Access Compliance Report

Public Rights-of-Way

Intersection ID: 54709	Main Street: MARY_BUTLER_WY	Cross Street: OLD_PROVIDENCE_RD	Location: SW
ADA ID: 0D5997DF9190	Ramp Type: Perp	Initial Pass/Fail: Fail	Overall Compliance: No
Severity Score: 13.75			
Codes/Mitigation Info/Possible Solution		Field Measurements/Component Compliance

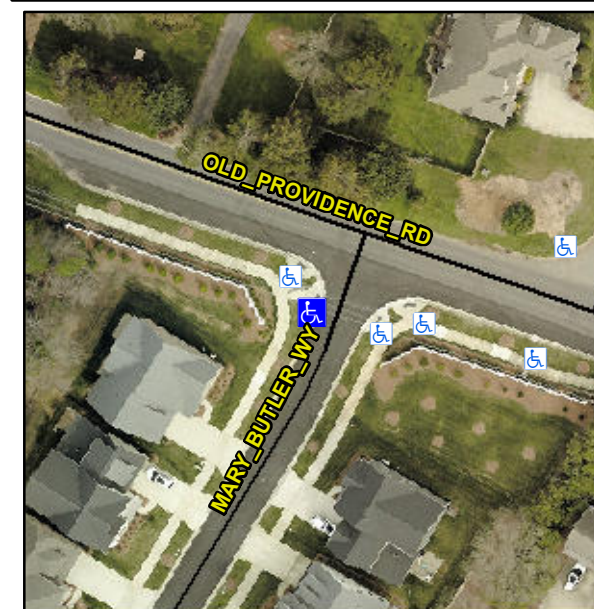
Not Found, R304.2.2, R304.5.3

Compliance	Description	Data	Compliance	Description	Data
N/A	Ramp Length (in)	95.0	No	Ramp Slope (%)	9.0
Yes	Ramp Width (in)	72.0	No	Ramp XSlope (%)	4.0
N/A	Flare Type LT	N/A	N/A	Flare Type RT	N/A
N/A	Flare Slope LT (%)	N/A	N/A	Flare Slope RT (%)	N/A
N/A	Flare Traversable LT?	N/A	N/A	Flare Traversable RT?	N/A
N/A	Landing Length (in)	N/A	N/A	DWS Provided?	N/A
N/A	Landing Width (in)	N/A	N/A	DWS Contrast?	N/A
N/A	Landing Slope (%)	N/A	N/A	DWS Length (in)	N/A
N/A	Landing X Slope (%)	N/A	N/A	DWS Full Width?	N/A
N/A	Landing Curb? (Y/N)	N/A	N/A	DWS Offset (in)	N/A
N/A	Shared Landing?	N/A			
N/A	Gutter Ponding?	N/A	N/A	Gutter Slope (%)	N/A
N/A	Gutter Lip Ht (in)	N/A	N/A	Gutter X Slope (%)	N/A
N/A	Painted X Walk1?	No	N/A	Painted X Walk2?	N/A
	X Walk 1 Direction	To SE		X Walk 2 Direction	N/A
N/A	X Walk 1 Width (in)	N/A	N/A	X Walk 2 Width (in)	N/A
	X Walk 1 Slope (%)	0.6		X Walk 2 Slope (%)	N/A
	X Walk 1 X Slope (%)	3.9		X Walk 2 X Slope (%)	N/A

Remove & Replace Entire Ramp.
